**Safety Evaluation Report
Amendment 7 to License SUA-1601
Regarding License Condition 11.3(A) & (B)
Strata Energy, Inc. Ross ISR Project
Crook County, Wyoming**

This safety evaluation report (SER) documents the NRC staff's review of this amendment request.

Figure 1. PHAST Model Output for the a) Nichols Ranch and b) Ross simulations
Source: NRC (2017c)

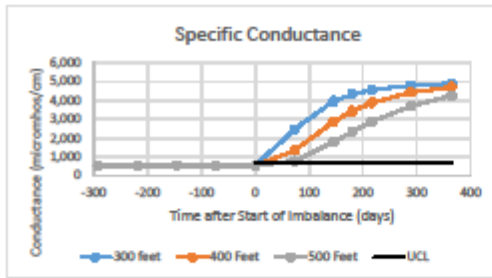
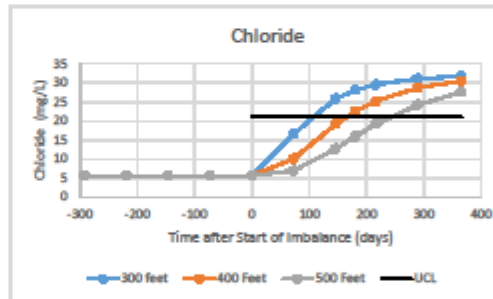
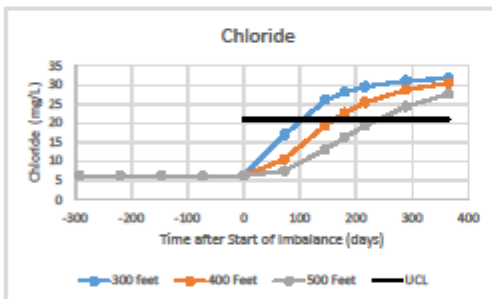
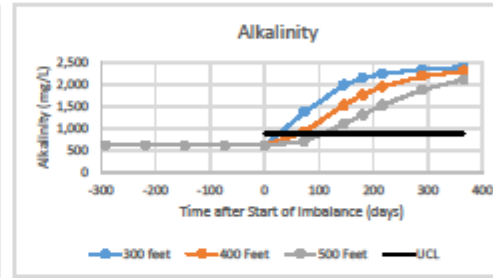
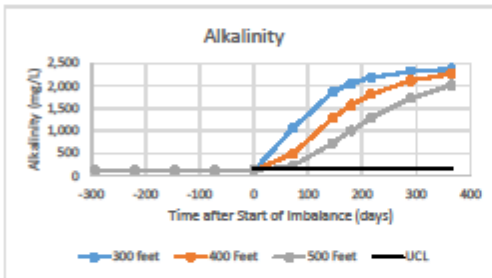
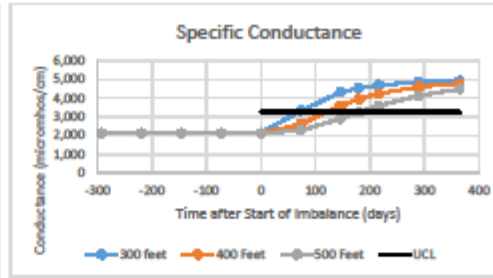
Results of the PHAST analysis are summarized in Table 3 and graphically shown on Figure 1. Based on the PHAST analysis, for all three constituents, the time to detect an excursion takes longer at the Ross facility at either 400 or 500 feet than it does at 500 feet at Nichols Ranch.

Based on the above, the NRC staff found that a distance greater than 400 feet to a perimeter well was not acceptable because of the increased time to detect an excursion. The 400-foot distance for the Ross facility had previously been approved by the NRC staff and is acceptable. A distance to the nearest production and perimeter well less than 400 feet is acceptable

because it would provide timelier detection of an excursion than at 400 feet. Therefore, the NRC staff found that Strata's request to amend License Condition 11.3(B) to allow variability in the distance to a monitoring well on the perimeter monitoring well ring was acceptable within the range of 300 to 400 feet.

Figure 2. Method for Determining Well-Specific Specific Conductance UCL for a Well at 440 feet

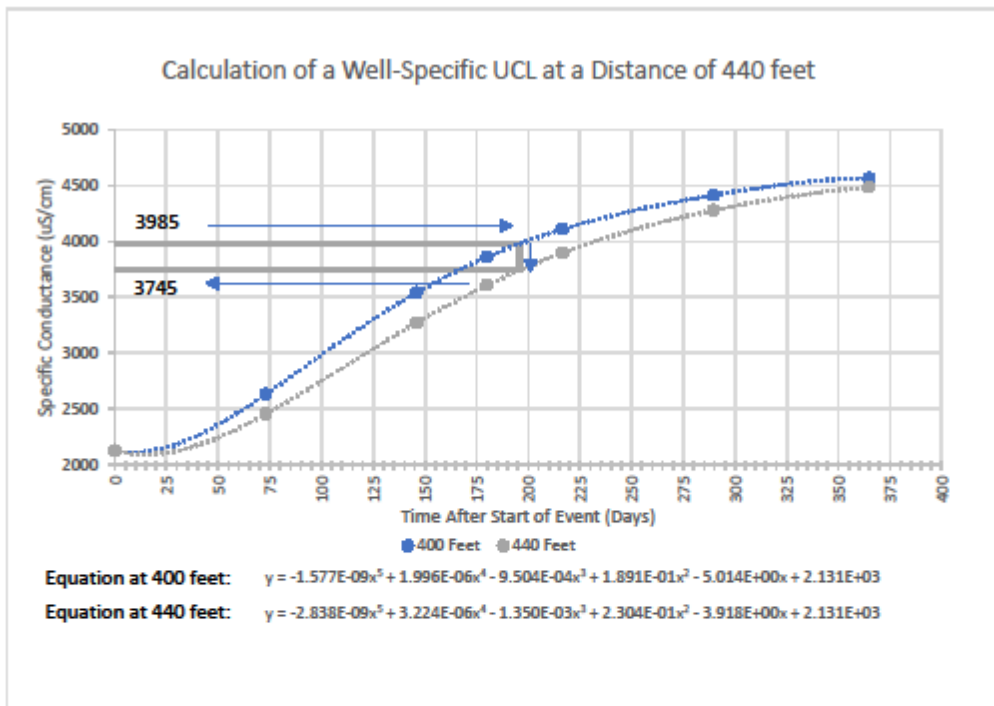
Strata provided in its response a five-step methodology and an example calculation for determining the well-specific specific conductance UCL for a well at a distance of 440 feet using Mine Unit 2 data (Strata, 2017b). In essence, Strata's methodology utilized four data points from NRC staff's modeling results (each datapoint was defined by time, distance and specific conductance), and, by linear interpolation from those points in both time and distance, calculated a well-specific specific conductance UCL. Using this method, Strata calculated a well-specific specific conductance UCL of 3,716 microSiemens per centimeter ($\mu\text{S}/\text{cm}$) for a well at 440 feet.

Third, NRC staff confirmed that Strata’s method to calculate a well-specific UCL (i.e., linear interpolation between data points) was appropriate. The NRC staff fitted the model-predicted specific conductance levels during the entire excursion event at both the 400- and 440-foot distance to a fifth-order polynomial equation for each respective distance. Then, using the polynomial equation for the 400-foot distance, the NRC staff determined the time to achieve the standard UCL. Next, using the time calculated above, the NRC staff estimated the specific conductance level at the 440-foot distance using its polynomial. The calculations are shown graphically on Figure 2. The NRC staff’s calculated well-specific specific conductance UCL at 440 feet is 3745 uS/cm, which is consistent with Strata’s calculated UCL of 3714 uS/cm.⁵

At the standard specific conductance level of 3985 uS/cm draw a horizontal line to the intersection of the curve for specific conductance at 400 feet, then continue with a vertical line (constant time) to the intersection of the curve for specific conductance at 440 feet, then a horizontal line to determine well-specific level. Alternatively, use the equation for the curve fitted to the data for 400 feet to solve for the time to the standard UCL, then using that time, solve the equation for the curve fitted to the data for 440 feet to solve for the specific conductance.
